APPLICATION FOR PERMIT TO DRILL OR REENTER

2. Name of Operator RKI Exploration and Production, L.L.C.		7. If Unit or CA Agreement, Name and No.
3a. Address 3817 NW Expressway, Suite 950 Oklahoma City, Oklahoma 73112		8. Lease Name and Well No. Santa Fe Federal 35 #24
3b. Phone No. (include area code) 405-996-5748		9. API Well No. 30-018-37277

PECOS DISTRICT CONDITIONS OF APPROVAL

OPERATOR'S NAME:	RKI EXPLORATION AND PRODUCTION, LLC
LEASE NO.:	NM67980
WELL NAME & NO.:	SANTA FE FEDERAL 35 #24
SURFACE HOLE FOOTAGE:	2310' FNL & 330' FEL
BOTTOM HOLE FOOTAGE:	' F L & ' F L
LOCATION:	Section 35, T. 22 S., R 28 E., NMPM
COUNTY:	Eddy County, New Mexico

REF: SANTA FE FEDERAL "35" #24 / WELL PAD TOPO

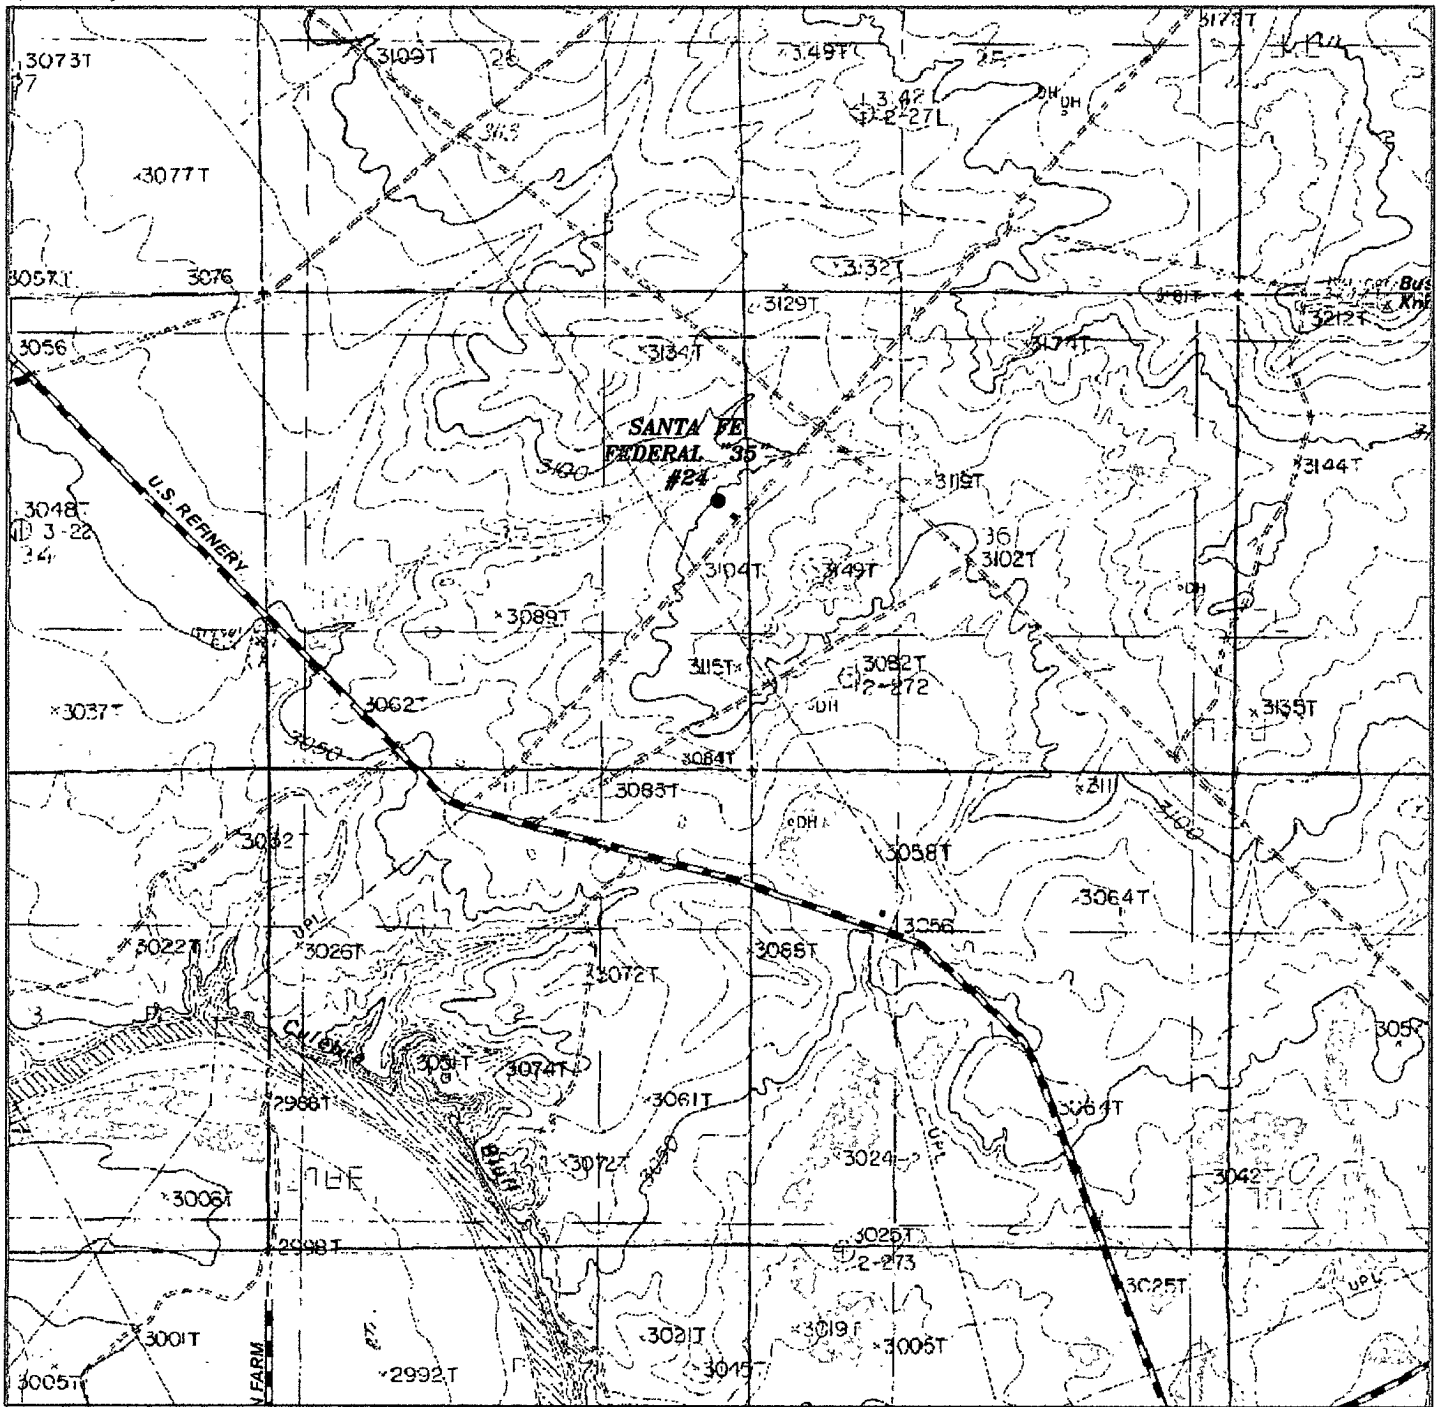
ON-SITE PERFORMED ON 8/06/09 RESULTED IN AN AGREEMENT TO REMOVE A PORTION OF THE NORTHWEST CORNER OF THE WELL PAD TO AVOID BEING IN THE DRAINAGE AREA TO THE NORTH. THE PROPOSED WELL LOCATION WAS NOT MOVED.

1. The northwest corner of the pad shall be reduced by 30 feet in order to avoid the drainage on the northwest side of the well location.
2. A trench and berm three feet in height shall be constructed around the southwest corner of the well pad in order to divert water around the well pad.
